SUBJECT: PRAIRIE ISLAND NUCLEAR GENERATING PLANT, UNIT NOS. 1 AND 2 -  
ISSUANCE OF AMENDMENTS RE: CREDIT FOR SOLUBLE BORON IN SPENT FUEL  
POOL CRITICALITY ANALYSES (TAC NOS. M93072 AND M93073)

The Commission has issued the enclosed Amendment No. 129 to Facility Operating License No. DPR-42 and Amendment No. 121 to Facility Operating License No. DPR-60 for the Prairie Island Nuclear Generating Plant, Unit Nos. 1 and 2, respectively. The amendments consist of changes to the Technical Specifications (TS) in response to your application dated July 28, 1995, as revised February 21, 1997.

The amendments revise the TS for the Prairie Island Nuclear Generating Plant to allow credit for soluble boron in spent fuel criticality analyses. The request is based on the NRC approval of the Westinghouse Owners Group generic methodology for crediting soluble boron given in Topical Report WCAP-14416-NP-A.

FIGURE TS.3.8-1 Spent Fuel Pool Unrestricted Region Burnup and Decay Time Requirements - OFA Fuel

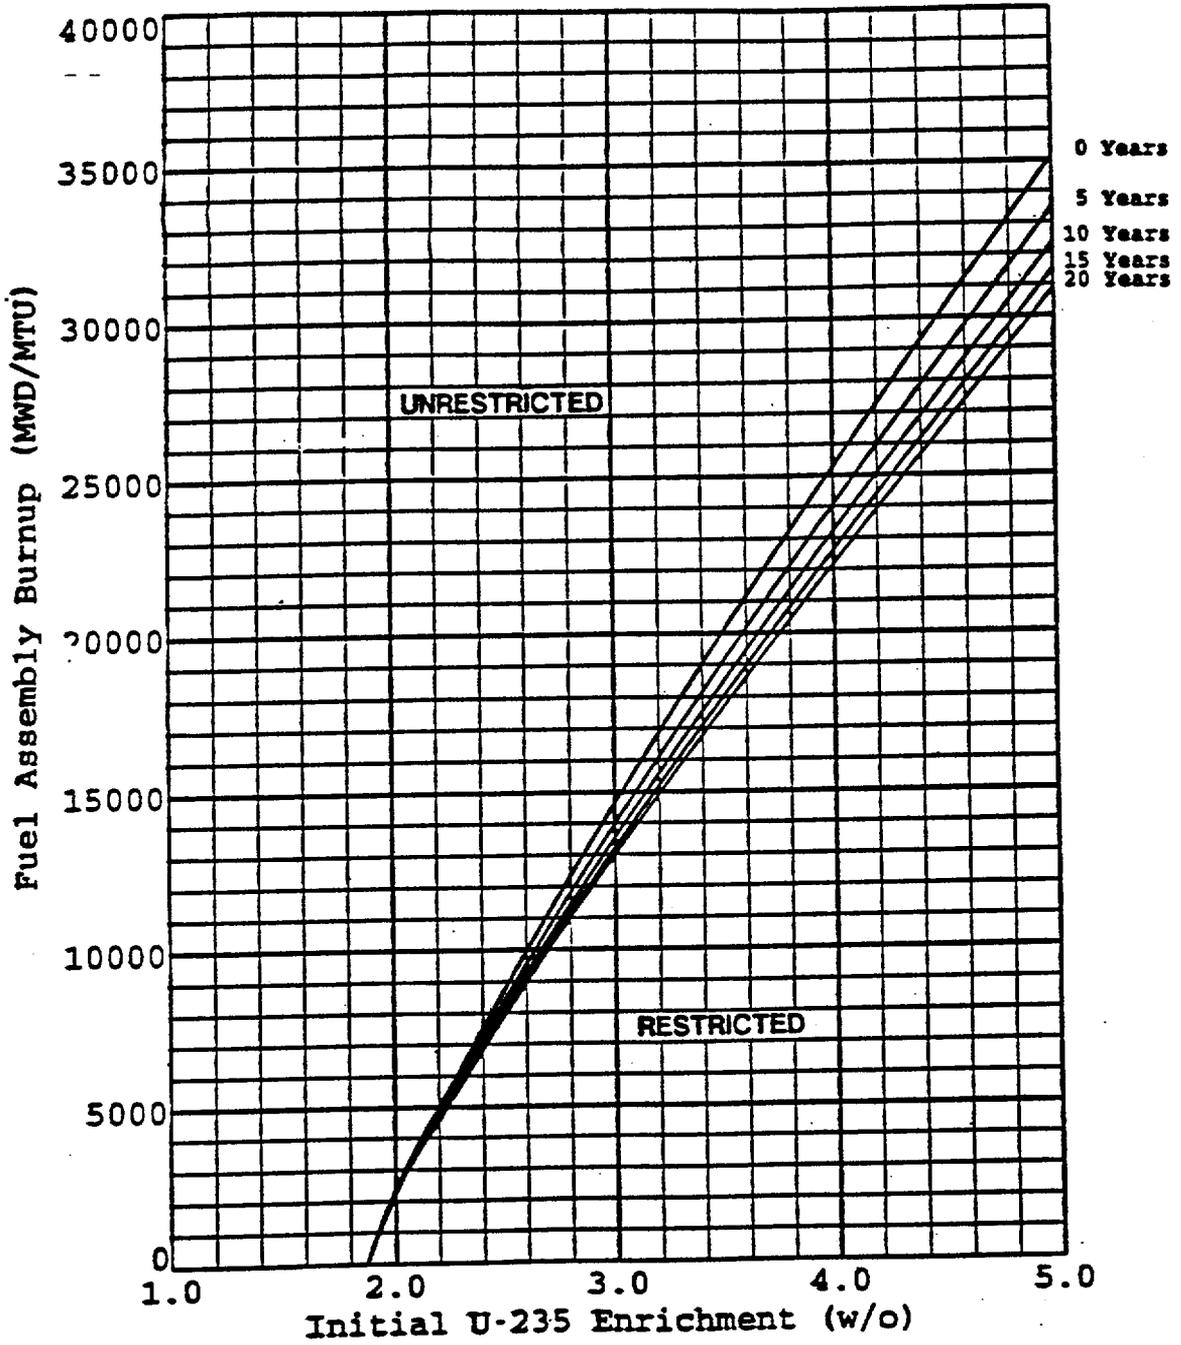
- a. The combination of initial enrichment, burnup and decay time of each spent fuel assembly stored in the spent fuel pool shall be within the unrestricted range of Figures TS.3.8-1 or TS.3.8-2, as applicable, or fuel assemblies shall be stored in accordance with Specification 5.6.A.1.e.
- b. If the requirements of 3.8.E.1.a are not met, immediately initiate action to move any noncomplying fuel assembly to an acceptable location.
- c. The provisions of Specification 3.0.C are not applicable.

- d. New or spent fuel assemblies with a combination of discharge burnup, initial enrichment and decay time in the unrestricted range of Figures TS.3.8-1 or TS.3.8-2, as applicable, may be allowed unrestricted storage in the spent fuel racks; and

- e. New or spent fuel assemblies with a combination of discharge burnup, initial enrichment and decay time in the restricted range of Figures TS.3.8-1 or TS.3.8-2, as applicable, will be stored in compliance with Figures TS.5.6-1 through TS.5.6-12.

FIGURE TS.5.6-1 Spent Fuel Pool Burned/Fresh Checkerboard Cell Layout

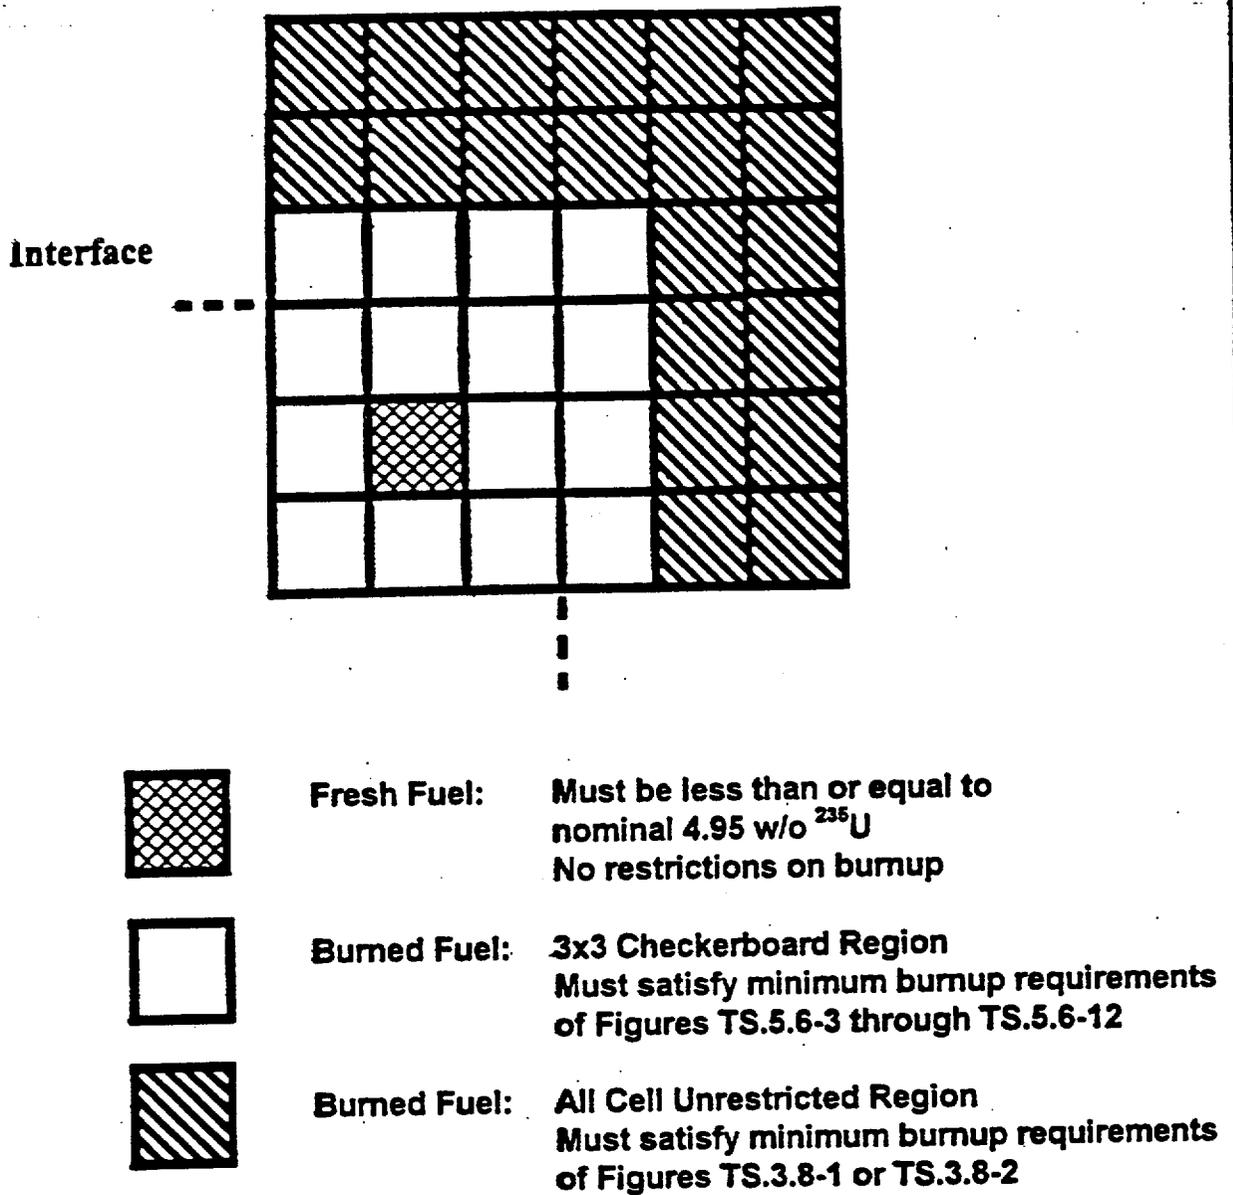
**Fresh Fuel:** Must be less than or equal to nominal 4.95 w/o <sup>235</sup>U  
No restrictions on burnup

**Burned Fuel:** Must satisfy minimum burnup requirements  
of Figures TS.5.6-3 through TS.5.6-12 depending  
on number of GAD rods in fresh fuel

Fuel assemblies that fall into the restricted range of Figures TS.3.8-1 or TS.3.8-2 are required to be stored in "fresh" cell locations as shown in Figure TS.5.6-1. The criteria included in Figures TS.3.8-1 and TS.3.8-2 for the selection of fuel assemblies to be stored in the "fresh" cell locations is based on a combination of fuel assembly type, initial enrichment, decay time and discharge burnup.

FIGURE TS.5.6-2 Spent Fuel Pool Checkerboard Interface Requirements

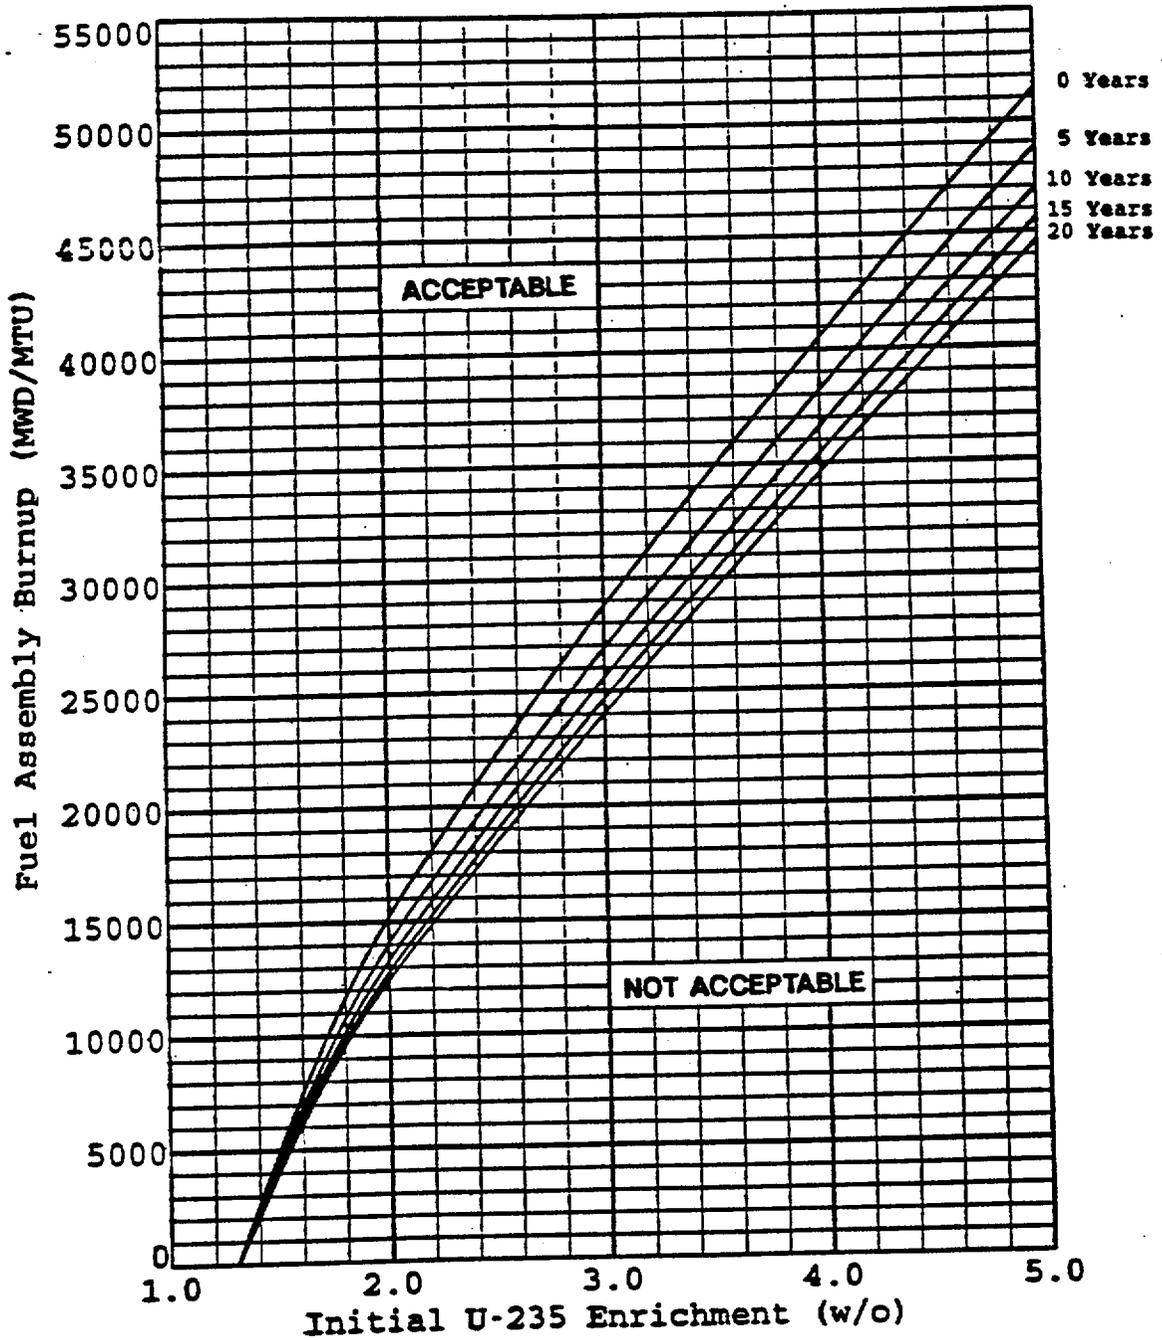
1. separated by a vacant row of cells, or
2. the interface must be configured such that there is one row carryover of the pattern of burned assemblies from the checkerboard region into the first row of the unrestricted region (Figure TS.5.6-2).

FIGURE TS.3.8-1 Spent Fuel Pool Unrestricted Region Burnup and Decay Time Requirements - OFA Fuel

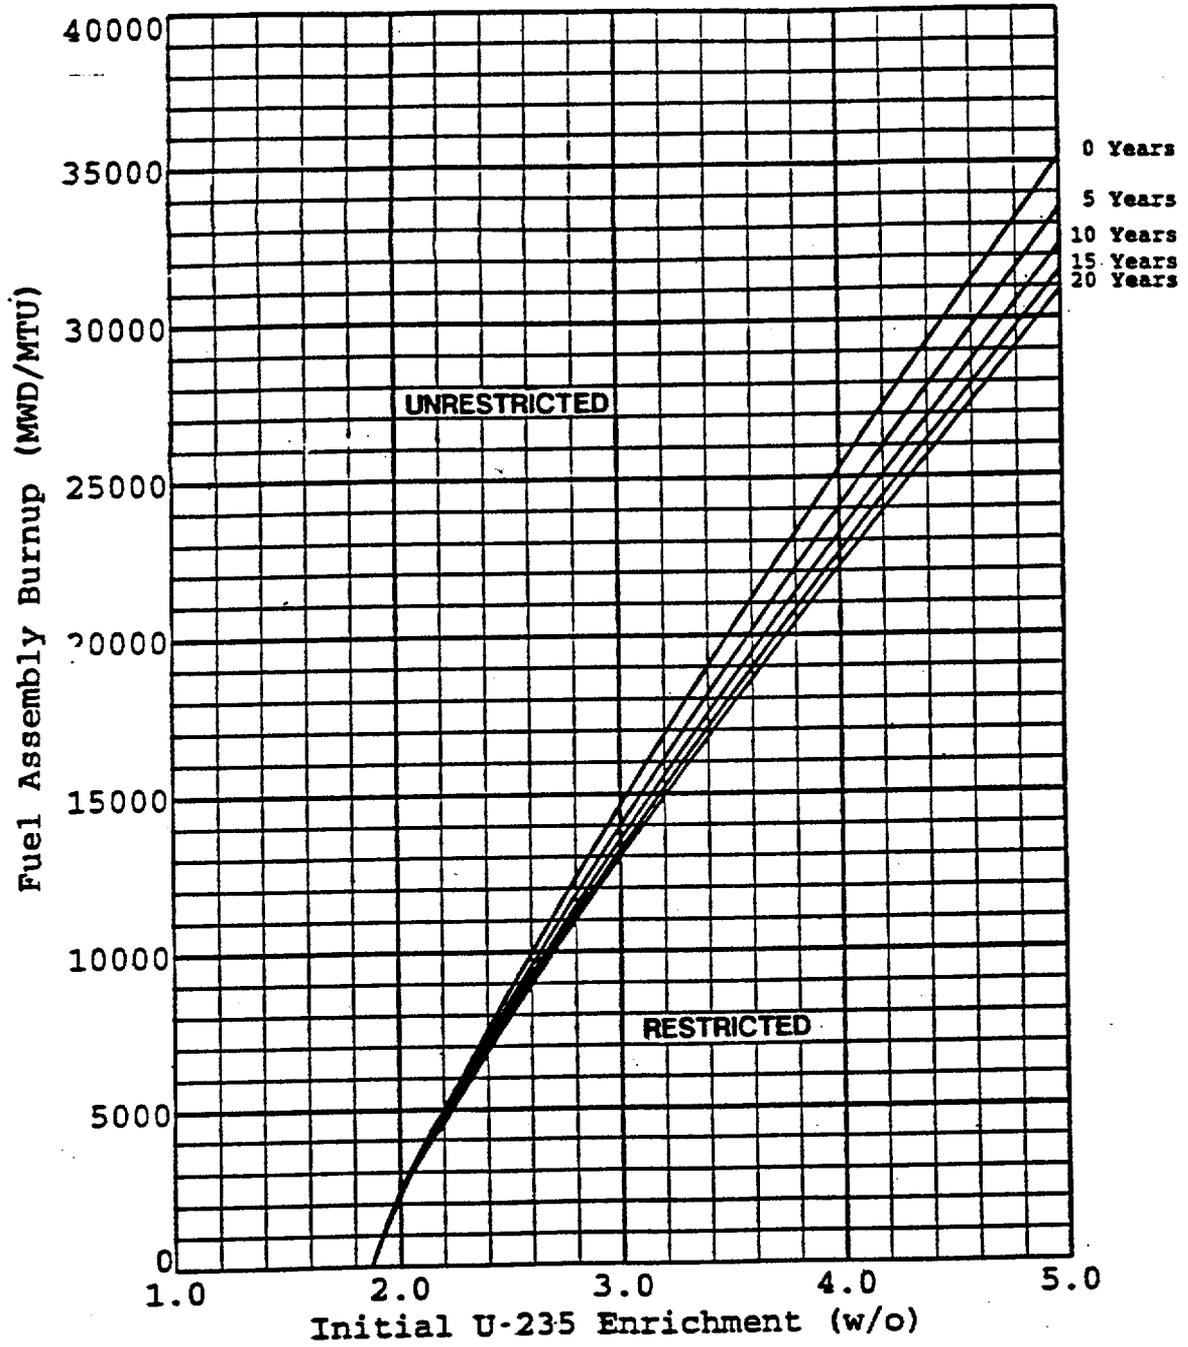
Fuel assemblies that fall into the restricted range of Figures TS.3.8-1 or TS.3.8-2 are required to be stored in "fresh" cell locations as shown in Figure TS.5.6-1. The criteria included in Figures TS.3.8-1 and TS.3.8-2 for the selection of fuel assemblies to be stored in the "fresh" cell locations is based on a combination of fuel assembly type, initial enrichment, decay time and discharge burnup.

FIGURE TS.5.6-1 Spent Fuel Pool Burned/Fresh Checkerboard Cell Layout

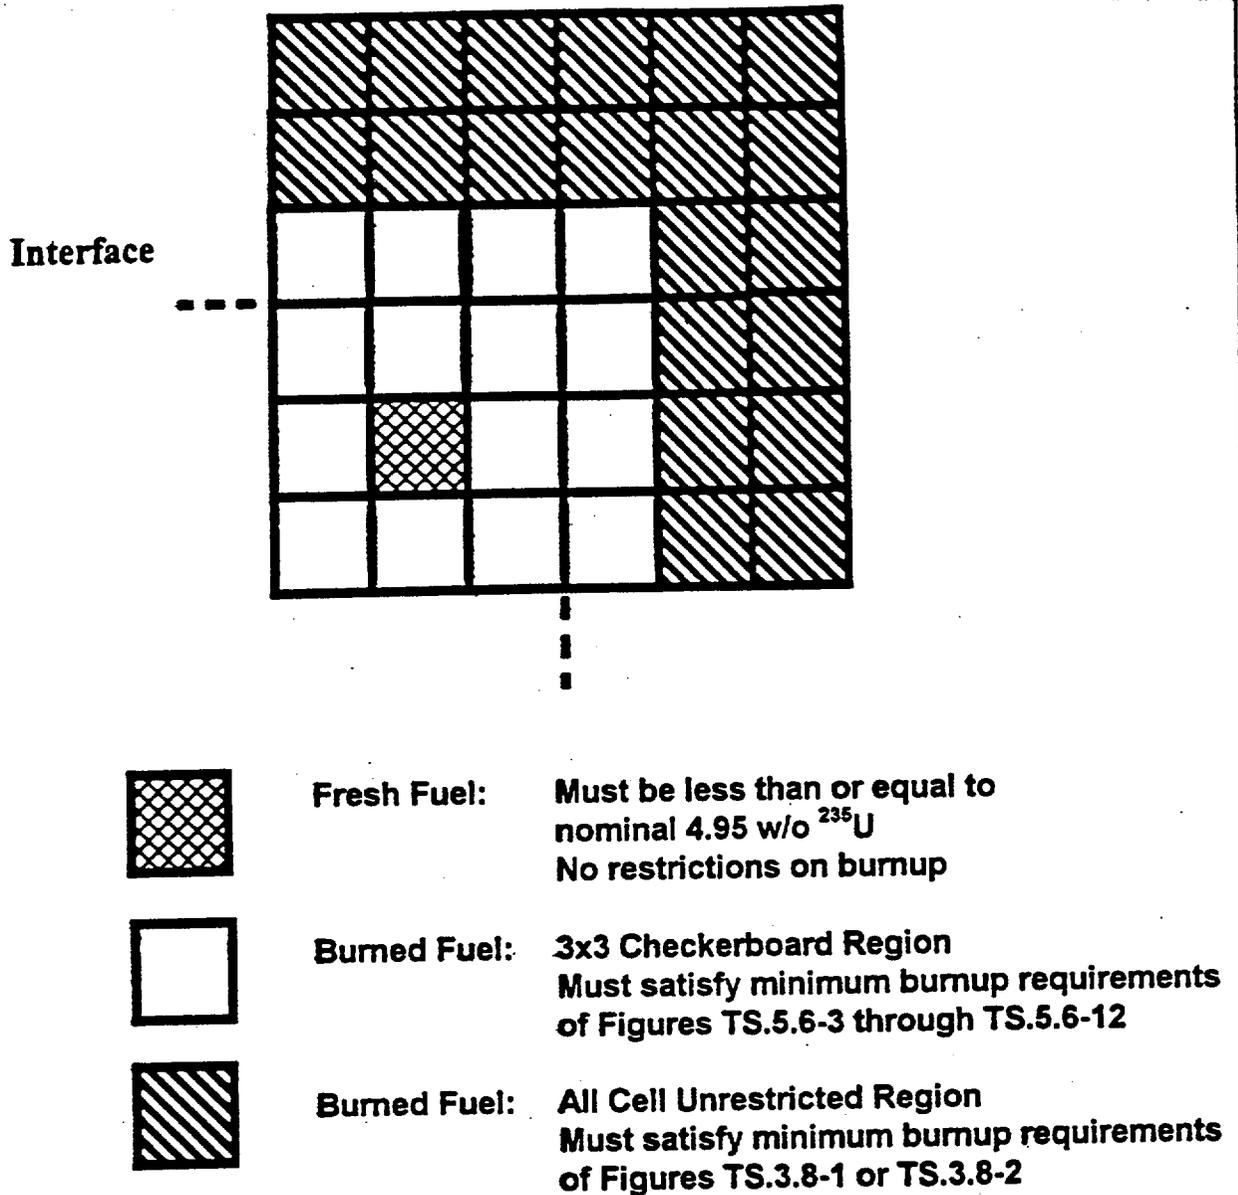
**Fresh Fuel:** Must be less than or equal to nominal 4.95 w/o <sup>235</sup>U  
No restrictions on burnup

**Burned Fuel:** Must satisfy minimum burnup requirements  
of Figures TS.5.6-3 through TS.5.6-12 depending  
on number of GAD rods in fresh fuel

FIGURE TS.5.6-2 Spent Fuel Pool Checkerboard Interface Requirements

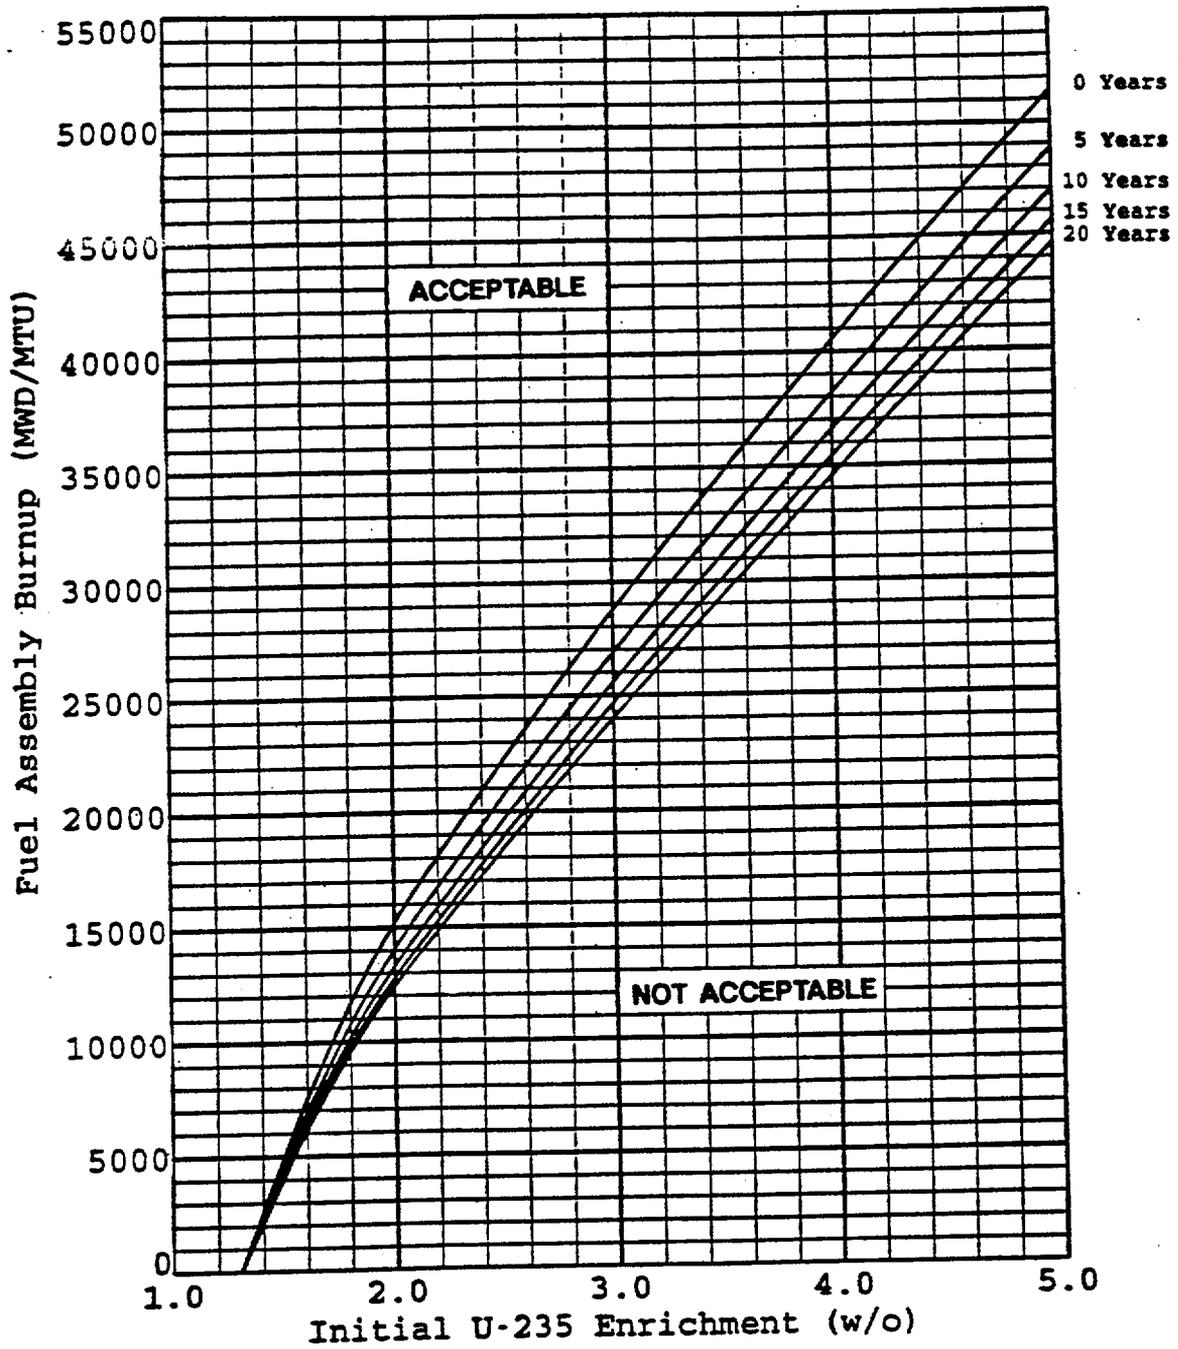
1. separated by a vacant row of cells, or
2. the interface must be configured such that there is one row carryover of the pattern of burned assemblies from the checkerboard region into the first row of the unrestricted region (Figure TS.5.6-2).
